**Draft global technical regulation on Evaporative emission
test procedure for Worldwide harmonized Light vehicle Test
Procedures (WLTP EVAP)**

Figure A1/1

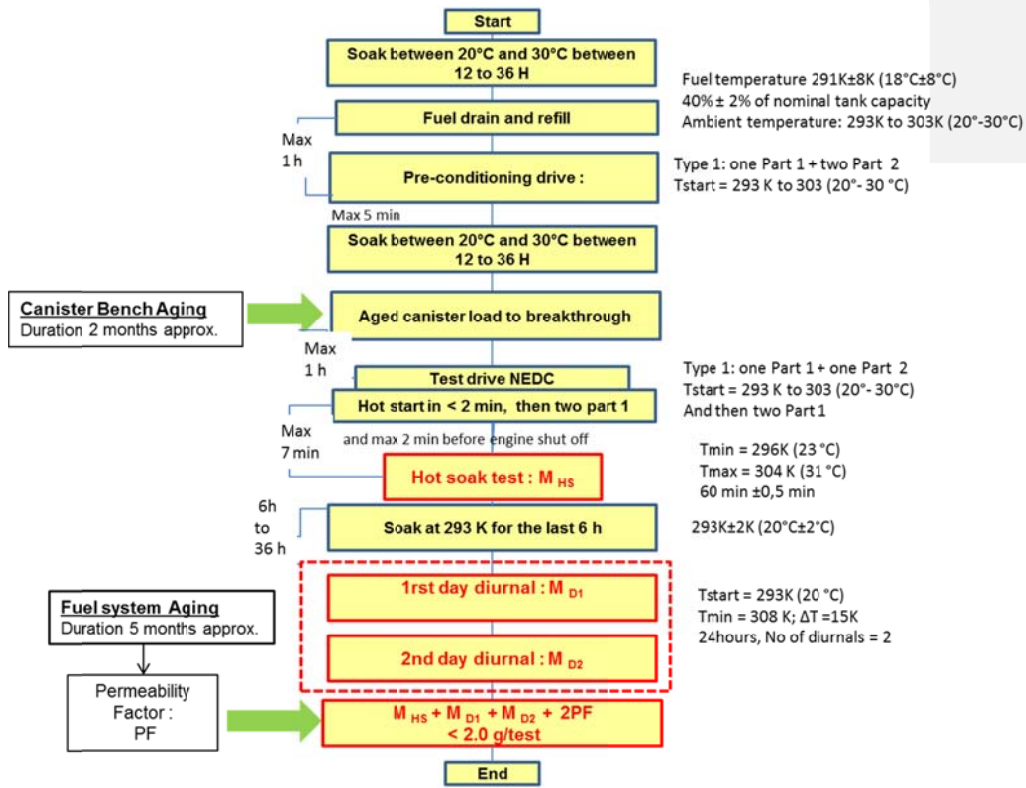
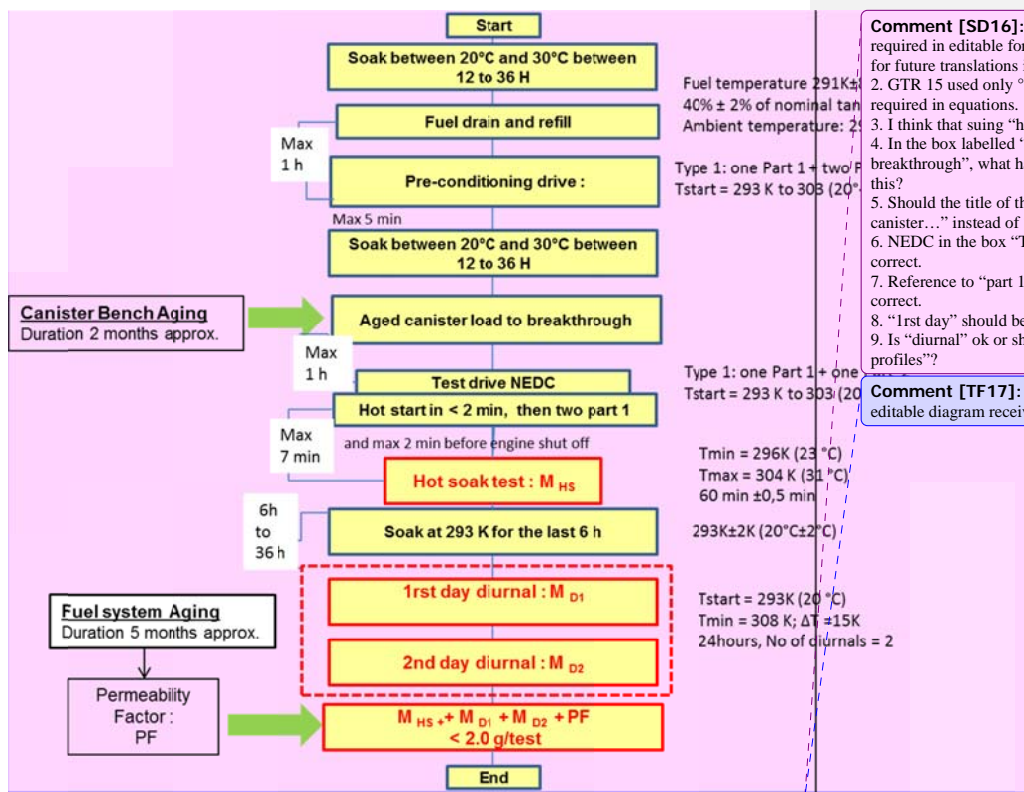
Comment [SD16]: 1. This diagram will be required in editable form, not just for now, but also for future translations into French and Russian.
 2. GTR 15 used only °C and only Kelvin where required in equations.
 3. I think that using "h" for hours is better than "H".
 4. In the box labelled "Aged canister load to breakthrough", what happens to the canister after this?
 5. Should the title of the box should be "Age canister..." instead of "Aged canister...?"
 6. NEDC in the box "Test drive NEDC" is not correct.
 7. Reference to "part 1" in the next box is also not correct.
 8. "1st day" should be "1st" day.
 9. Is "diurnal" ok or should we refer to "diurnal profiles"?

Comment [TF17]: These will be taken care after editable diagram received.

Figure A1/4: Determination of the PF

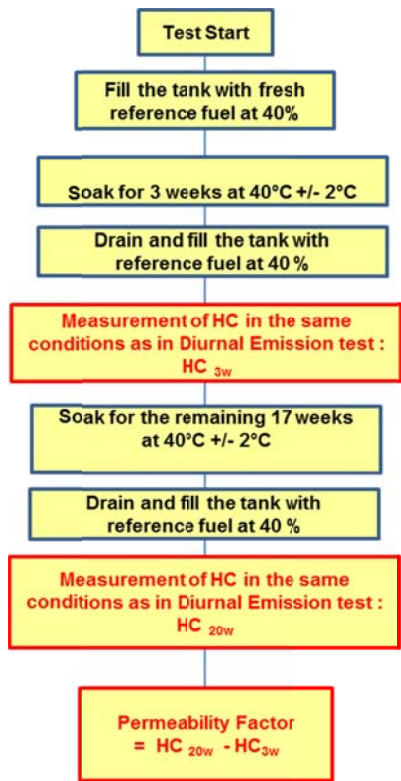
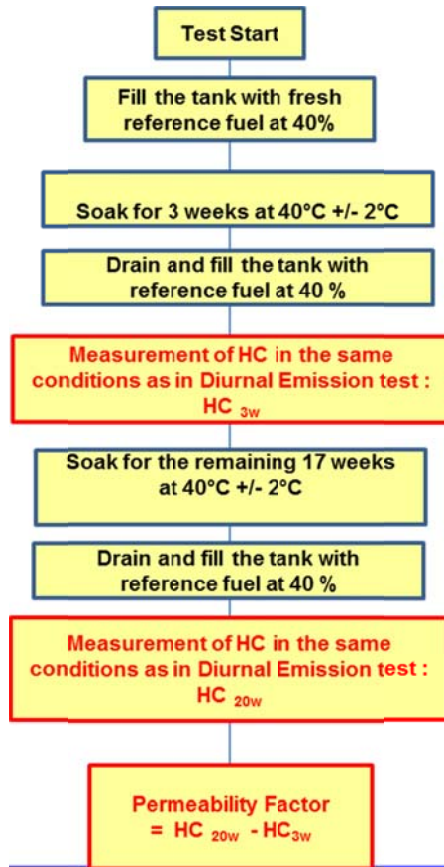
Comment [SD27]: This diagram should be in editable form.
